Subject: AP1000 Response to Request for Additional Information (SRP3.7.1)

Response to Request for Additional Information on SRP Section 3.7.1

AP1000 TECHNICAL REPORT REVIEW

RAI Response Number: RAI-SRP3.7.1-SEB1-02
Revision: 1

RAI-SRP3.7.1-SEB1-10-2: ASB at Elevation 327.4' Y-Direction

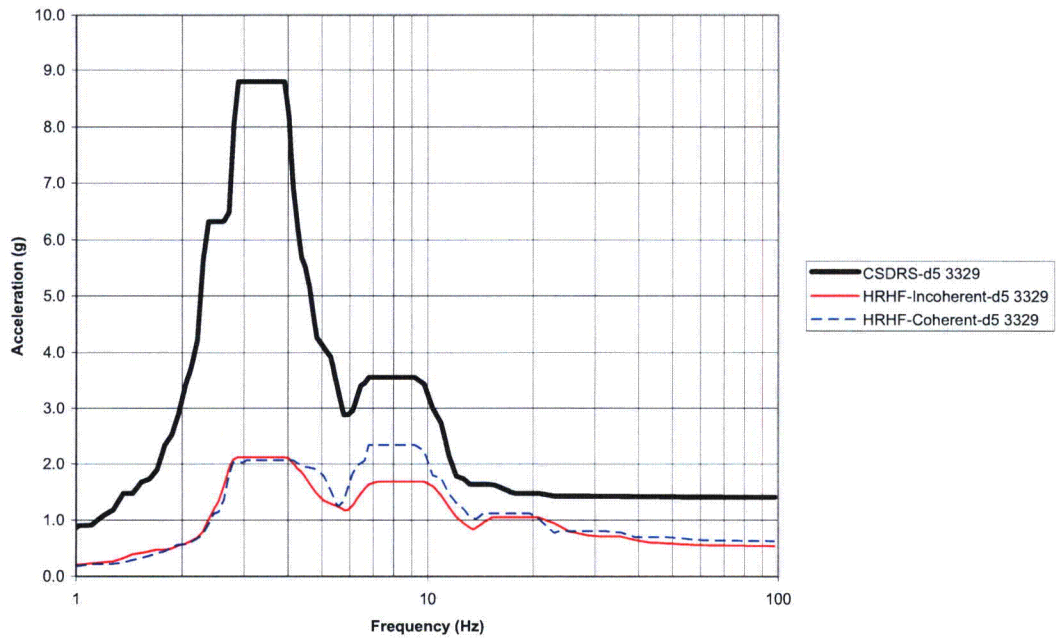
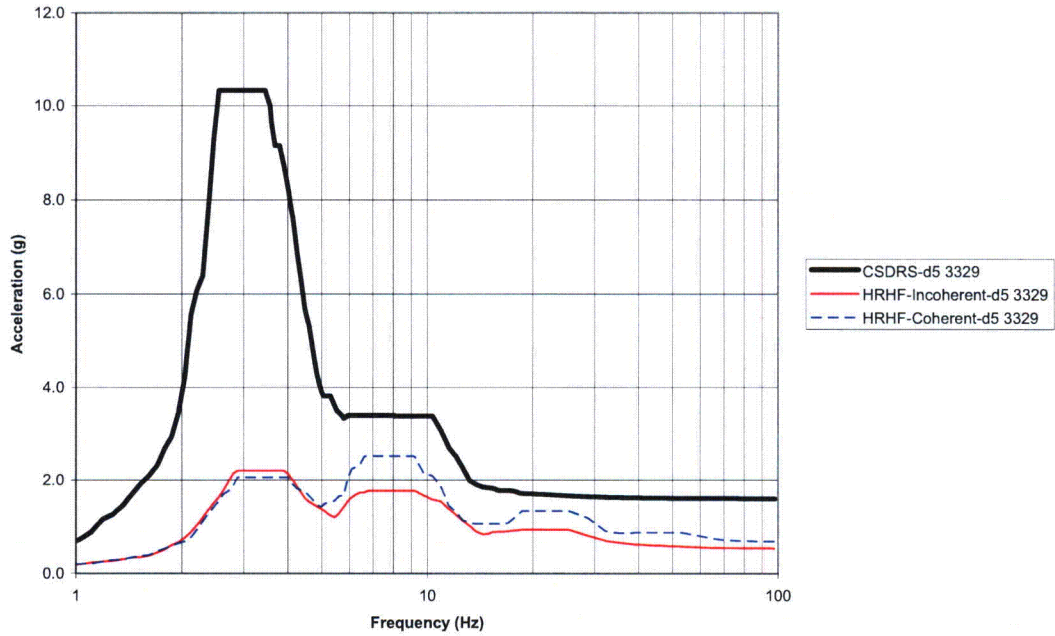
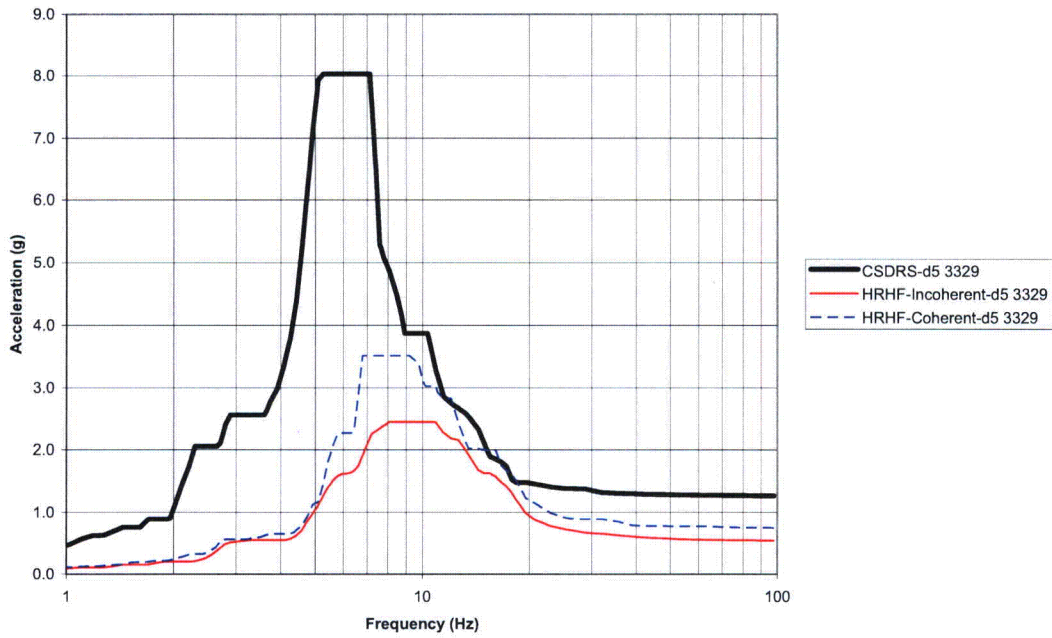
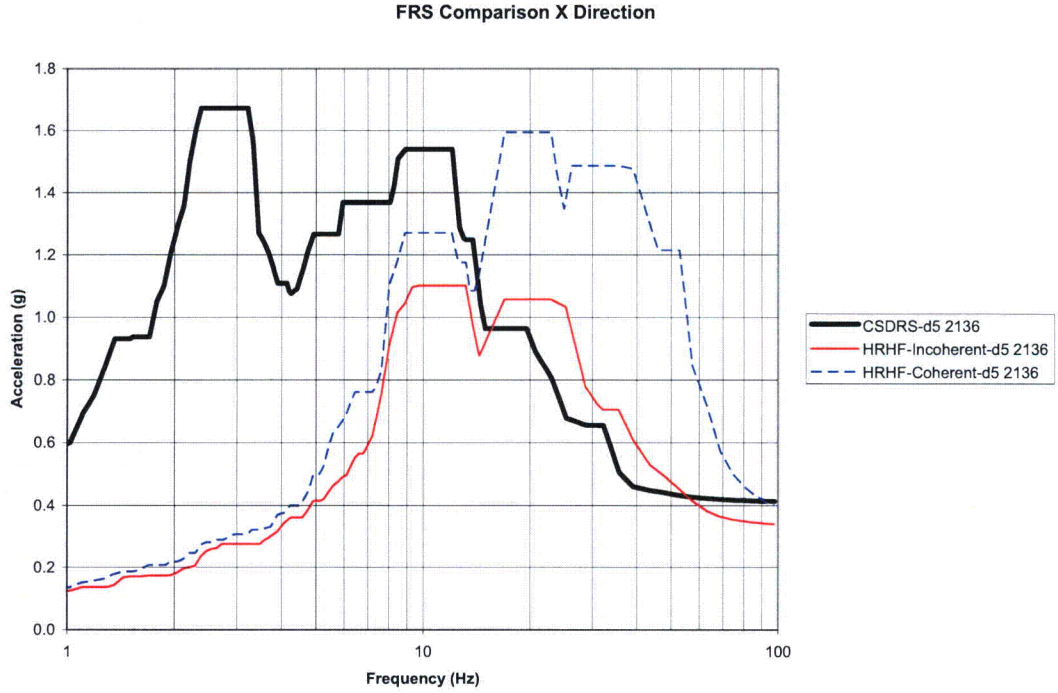
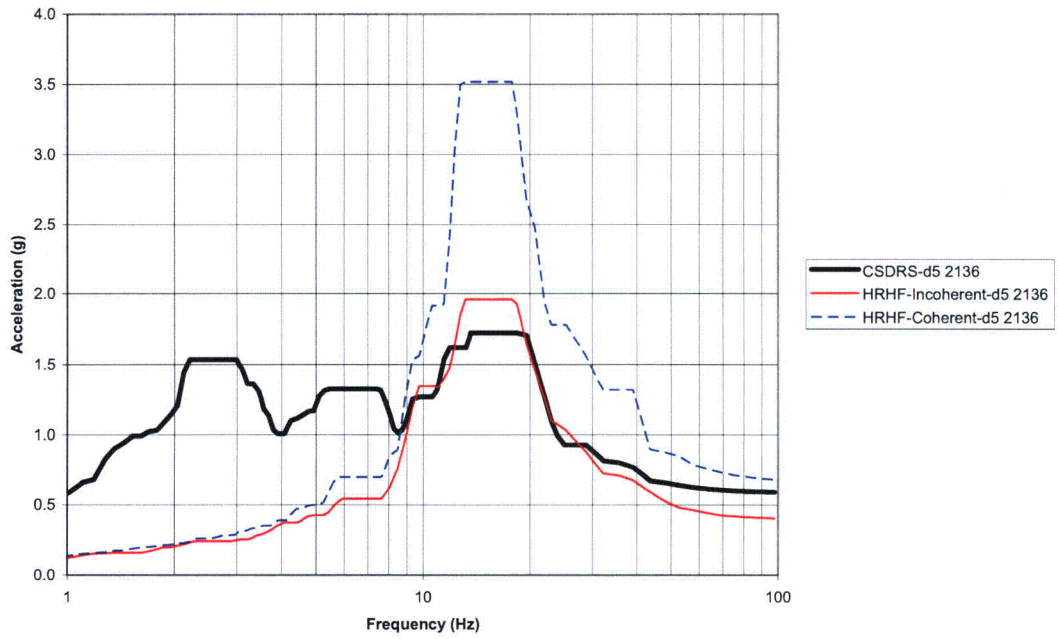
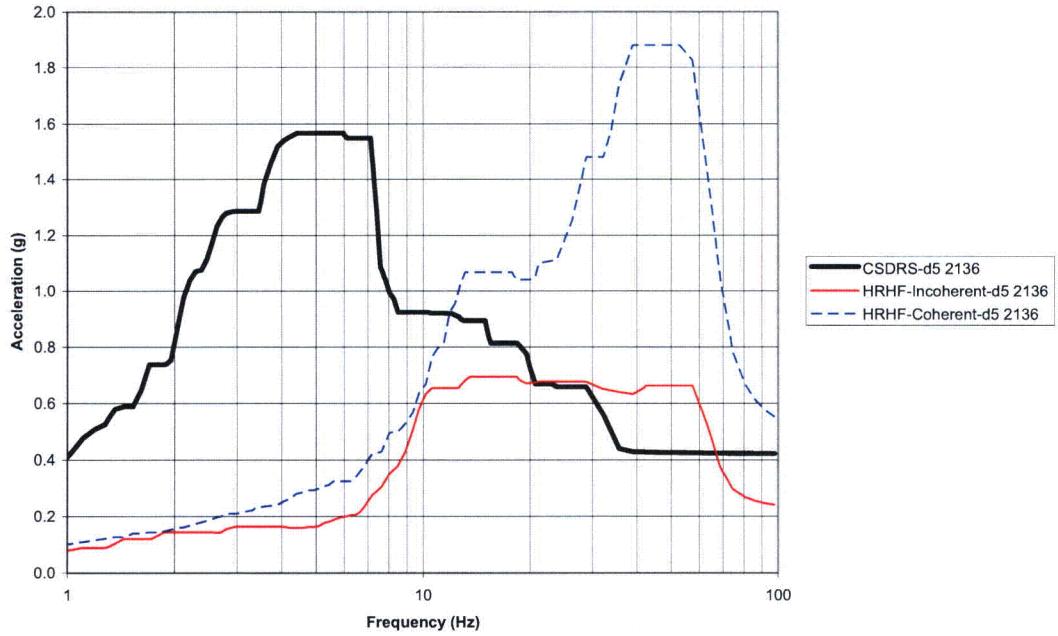
The staff requests that Westinghouse augment Figures 5.2-1 through 5.2-6 in TR-115, by adding the HRHF broadened spectra from the NI20 fixed base analysis, without any reduction for incoherency or other considerations. This will provide the staff with results needed to conduct an evaluation of the effect of incoherency.

In response to the question raised by the NRC during May 19-23, 2008, Westinghouse has provided the response spectra for the HRHF broadened NI20 model with coherent and incoherent considerations in Figure RAI-SRP3.7.1-SEB1-10-1 to RAI-SRP3.7.1-SEB1-10-21 (5% damping).

Technical Report (TR) Revision: ~~None~~ The Figure RAI-SRP3.7.1-SEB1-10-1 to RAI-SRP3.7.1-SEB1-10-21 will replace Figure 5.2-1 through 5.2-6 in TR-115. See also RAI-SRP3.7.1-SEB1-11 for changes to Section 5.2.

RAI-SRP3.7.1-SEB1-11-1: Seismic Response Spectra on roof of Shield Building X-Direction

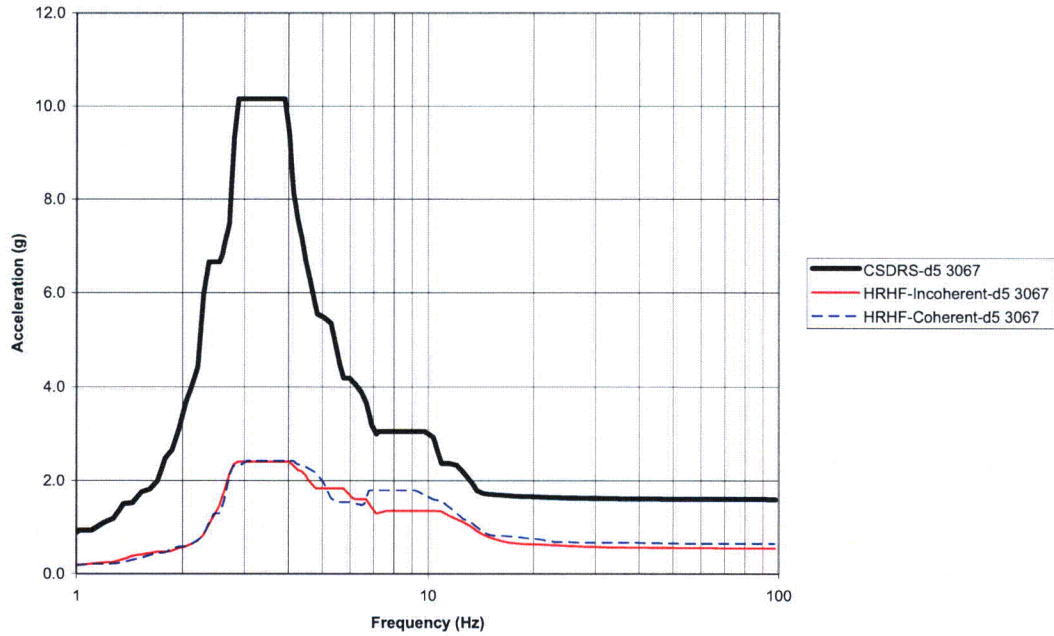
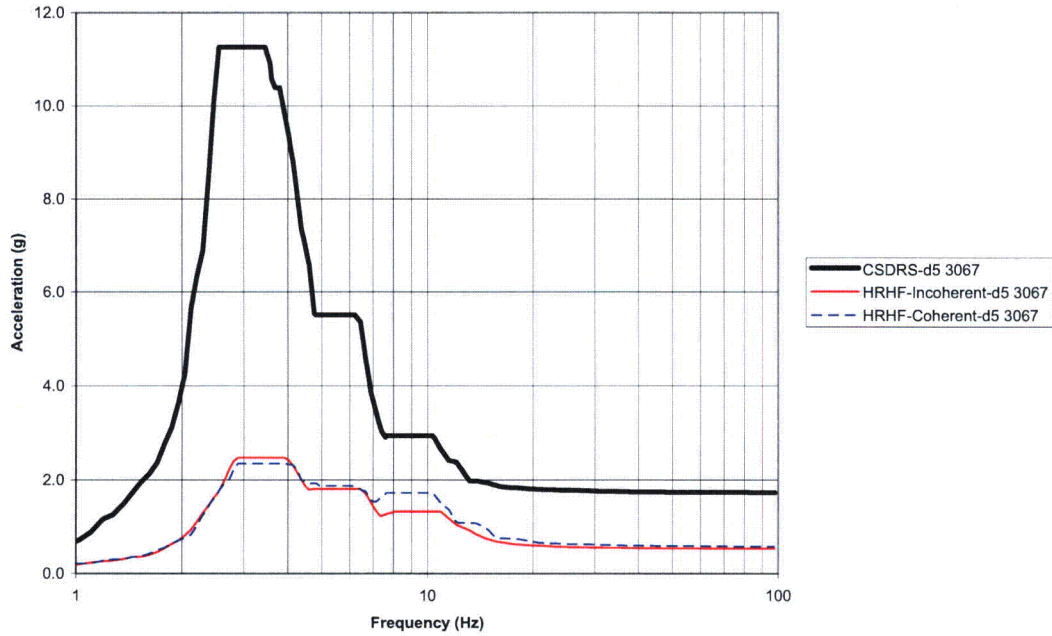
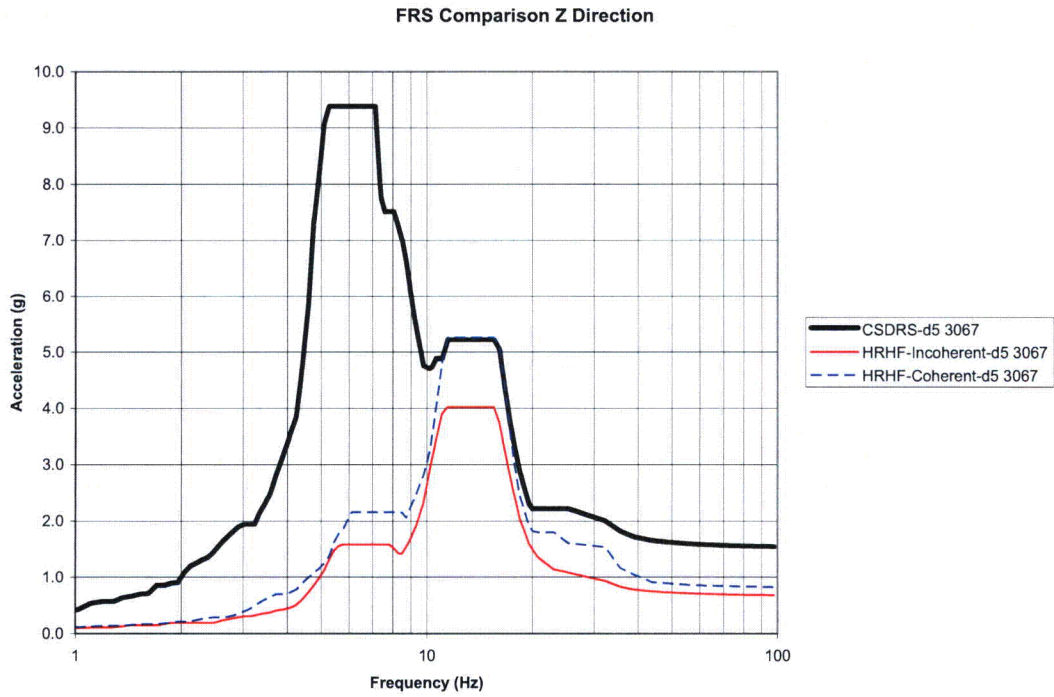
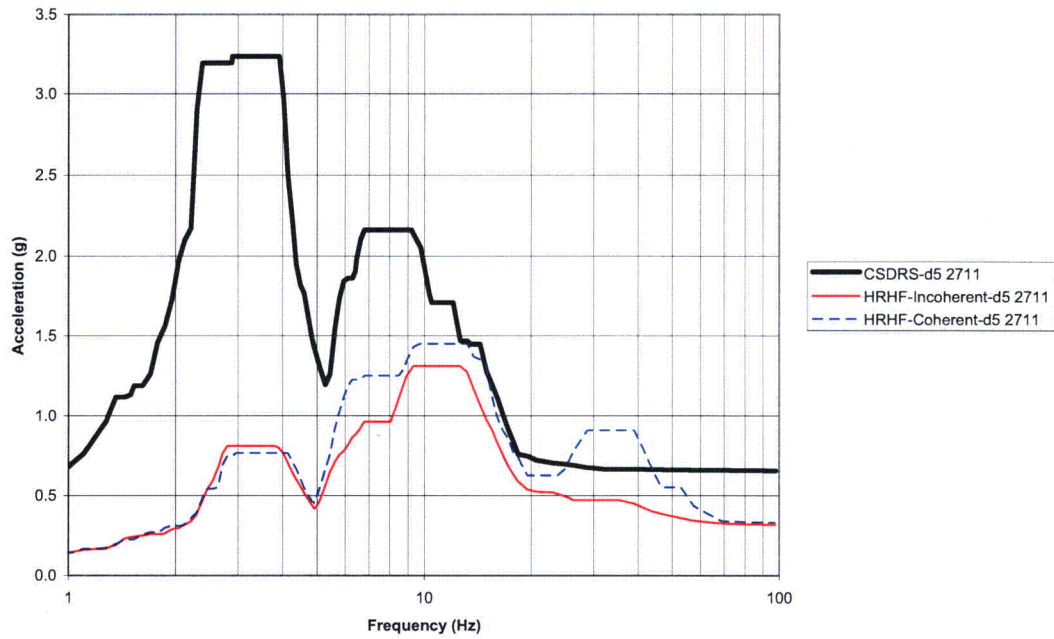
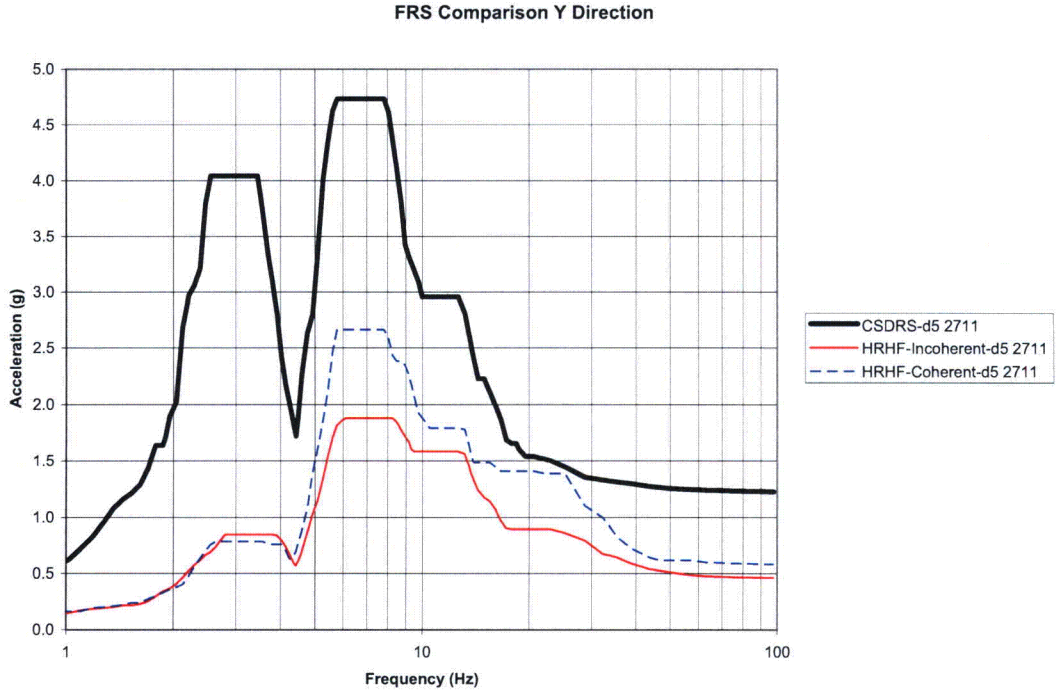
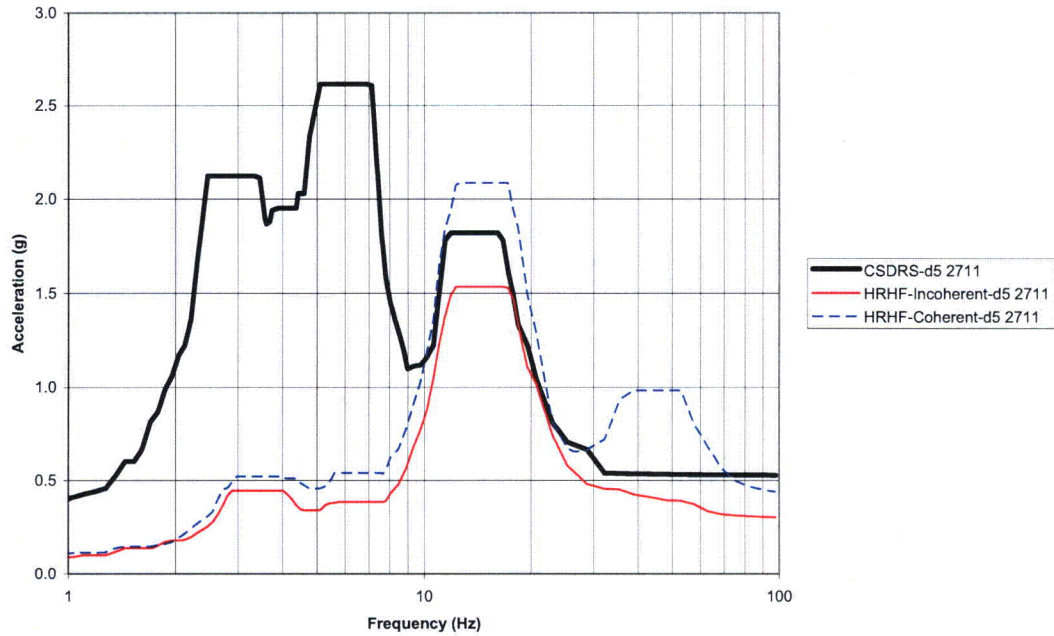
The staff requests that Westinghouse provide additional figures in Section 5.2 TR-115, to include all location/direction combinations presented in the Section 5.1 figures, and to provide a cross-reference between the corresponding 5.1 and 5.2 figures.

In response to the NRC's request to supplement Section 5.2 in the TR-115 during May 19-23, 2008, Westinghouse has provided incoherent and coherent comparison response spectrum for the nodal locations presented in TR-115 Section 5.1. These spectra are presented below in Figure RAI-SRP3.7.1-SEB1-11-1 to RAI-SRP3.7.1-SEB1-11-9 (5% damping).

~~None~~ The figures presented in this response request will be added to Section 5.2 of the TR-115 to supplement the existing data as Figures 5.2-7 and 5.2-8. Note that Figure 5.2-5 will be replaced by Figures RAI-SRP3.7.1-SEB1-11-4 to RAI-SRP-SEB1-11-6. Each figure will have the floor response spectra associated with the X, Y, and Z response. See also RAI-SRP-3.7.1-10 for additional changes to Section 5.2.
